Additional Information on ARC100 Fuel Qualification

Pavel Medvedev (INL)

Robert Iotti (ARC Clean Technology)

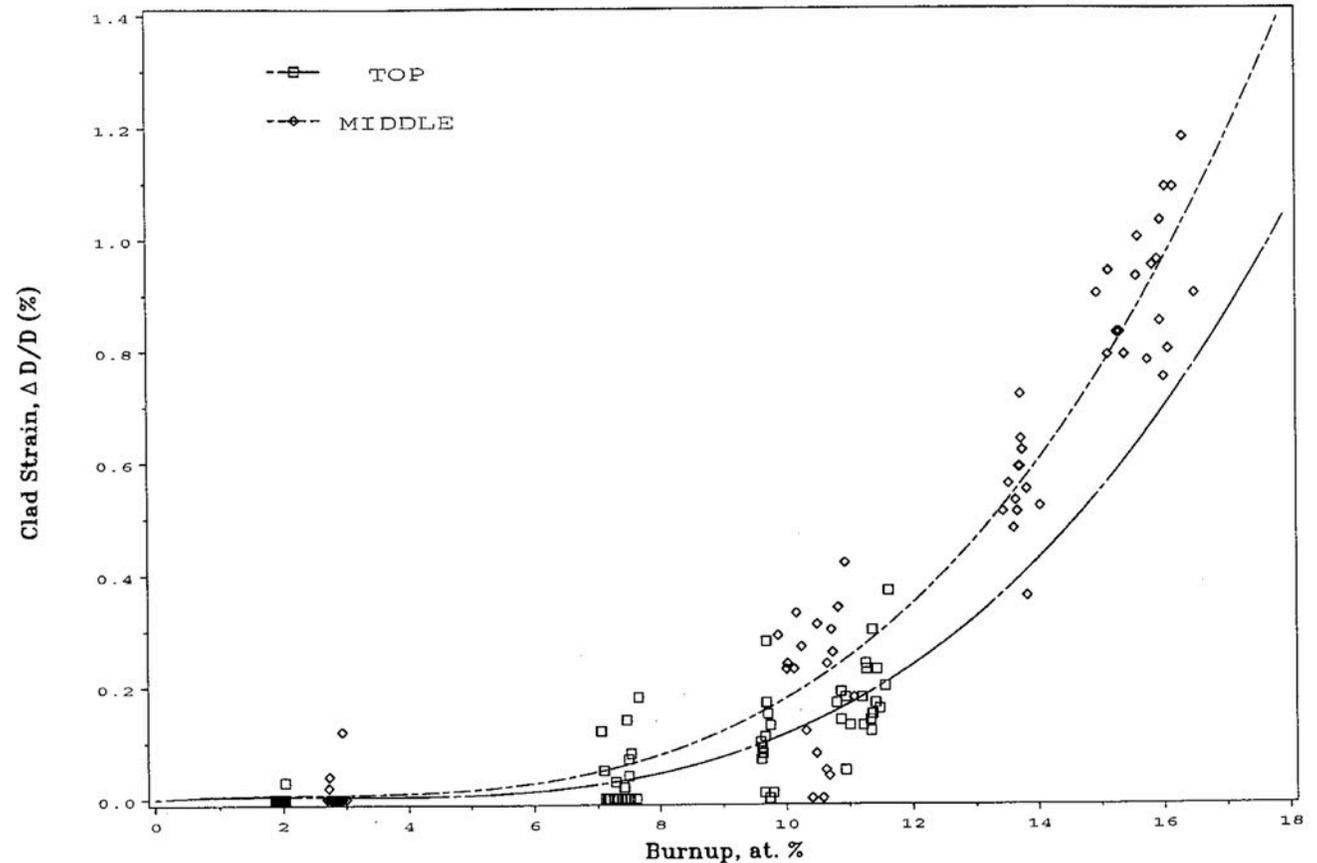
On slide 7, ARC presented [[[REDACTED]]] irradiation tests and provided a comparative evaluation. The staff inquired about the details in the graph and the meaning of the [[[REDACTED]]]. ARC clarified that the [[[REDACTED]

[REDACTED]]]. ARC further emphasized that, in its FEA, it used the actual geometry and irradiation history of the pin. Citing the comparative evaluation, ARC stated that the experimental and modeling results were in good agreement. In response, the staff asked for a clarification on a [[[REDACTED]

[REDACTED]]]. ARC stated it is still trying to understand the difference and had two initial rationales: [REDACTED]

[REDACTED]]]. ARC stated that there is currently reasonable agreement for these preliminary results, but the results will be refined in the future
